CITY OF ALBUQUERQUE

RE: **Explore Academy**
5100 Masthead NE
Conceptual Grading and Drainage Plan
Engineer's Stamp Date 3/12/18
Hydrology File: D17D003N

Based on the information provided in your submittal received 3/14/18, the above referenced plan is approved for Site Plan for Building Permit.

GRADING AND DRAINAGE PLAN
WEST ADDITION

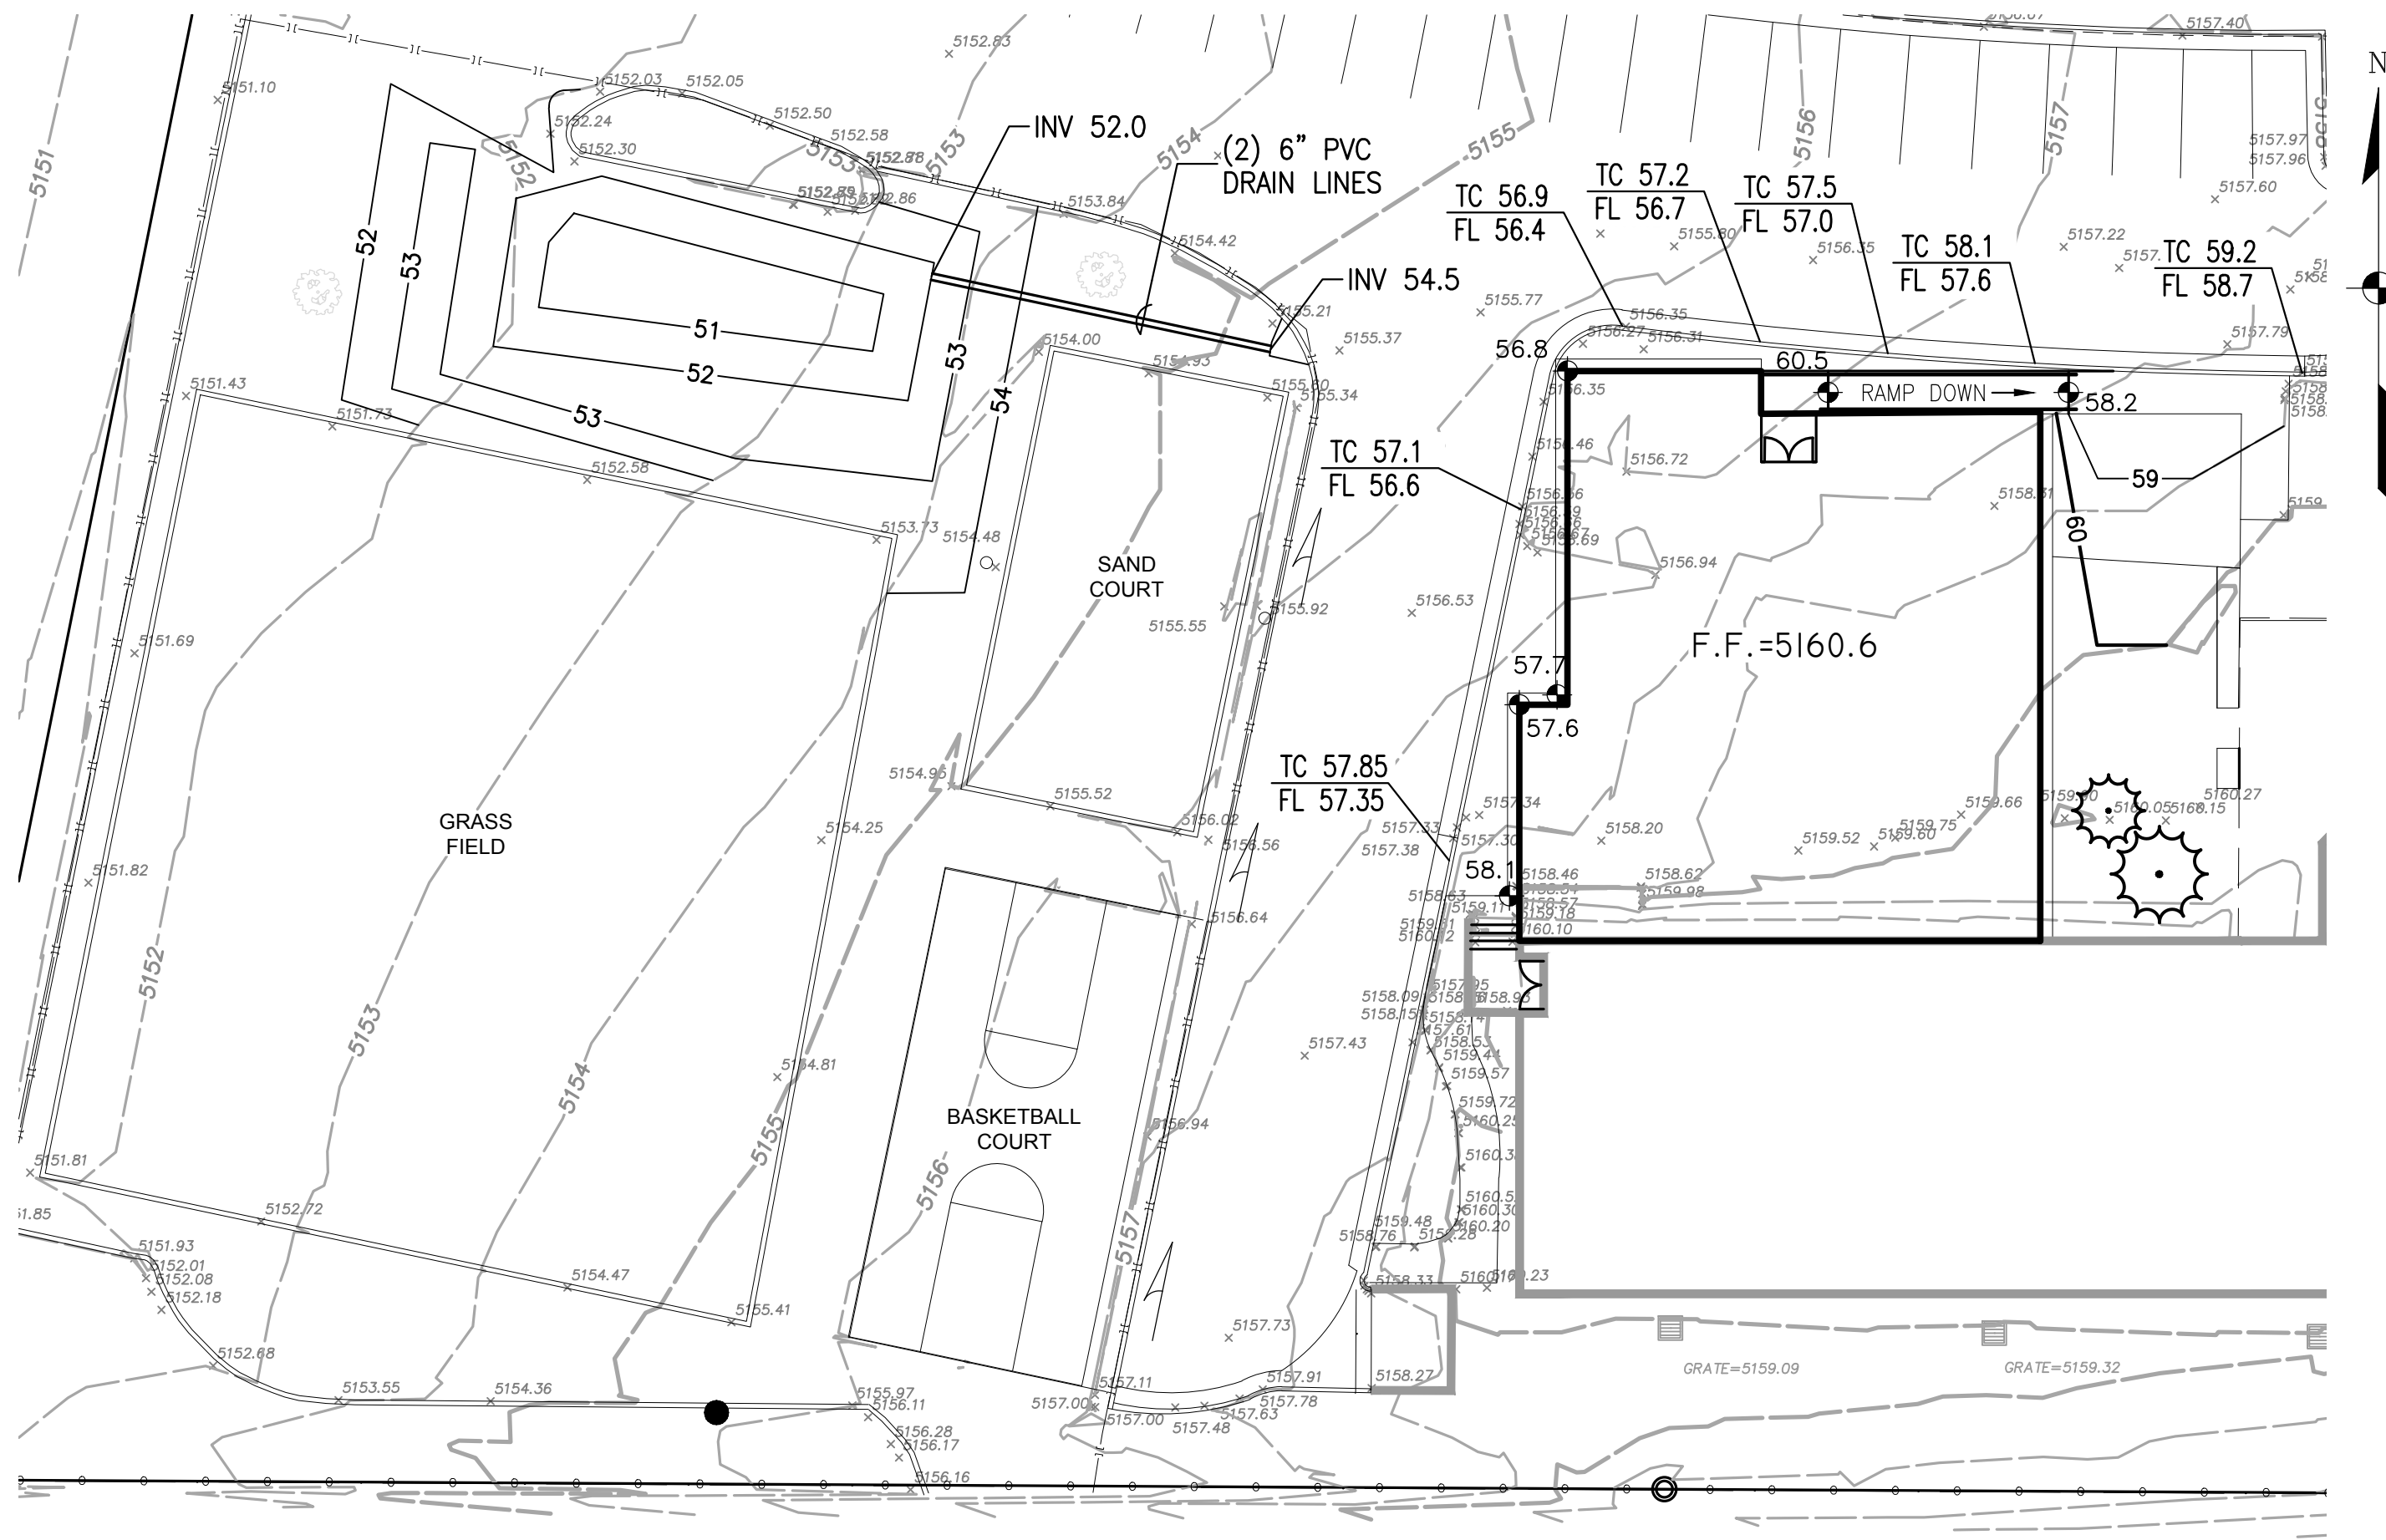
1. Provide a detail for the 6" pipe inlets. Will these have a concrete apron and end section? Will they be grated? Will there be a local depression to prevent bypass flows?
2. A Private Facility Drainage Covenant is required for the stormwater quality pond. The original notarized form, exhibit A (legible on 8.5x11 paper), and recording fee (\$25, payable to City of Albuquerque) must be turned into DRC (4th, Plaza del Sol) for routing. Please contact Charlotte LaBadie (clabadie@cabq.gov, 924-3996) or Madeline Carruthers (mtafoya@cabq.gov, 924-3997) regarding the routing and recording process for covenants.
3. Additional comments may be provided at Building Permit, based on the outcome of the above remarks and level of detail shown on plans.
